18 April 2023

NSW Health Infrastructure
1 Reserve Road
ST LEONARDS NSW 2065

**RE: WENTWORTH HEALTH SERVICE – REF WORKS
24 HOSPITAL ROAD, WENTWORTH NSW 2648
BCA / ACCESS COMPLIANCE STATEMENT FOR REF SUBMISSION (R3)**

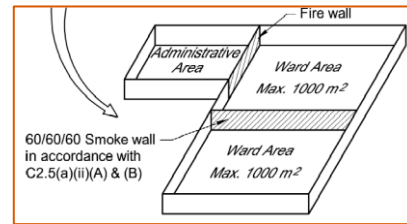
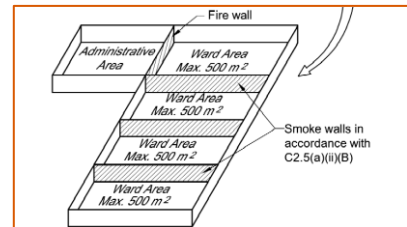
C1.10	<p><u>Early Fire Hazard Properties:</u> The fire hazard properties of all new building materials and assemblies used in the development must comply with the requirements of C1.10 and all new floor materials, floor coverings, wall and ceiling lining materials must comply with Specification C1.10 – <i>Test reports of any floor or wall coverings required at Completion Certificate stage.</i></p>
C2.5	<p><u>Fire and Smoke Compartments:</u></p> <p>Patient care areas need to be separated into maximum 2,000m² <u>fire compartments</u> by fire walls having an FRL of 120/120/120. Non-patient care areas (BOH non-clinical) may be increased to maximum 5,000m² <u>fire compartments</u>.</p> <p>Compartmentation is to be as follows:-</p>

- i) Where the floor area exceeds 1,000m², then it must be divided into compartments of not more than 1,000m², by walls with an FRL of not less than 60/60/60, and

- ii) Where the floor area exceeds 500m², then it must be separated into further compartments of not more than 500m², by smoke proof walls complying with the requirements of Specification C2.5, and

- B. Treatment areas must be divided into compartments of not more than 1,000m², by smoke proof walls complying with Specification C2.5.

Fire walls are to comply with BCA C2.7. The building structure, including the steel roof structure, must be designed so as not to cross the fire walls.
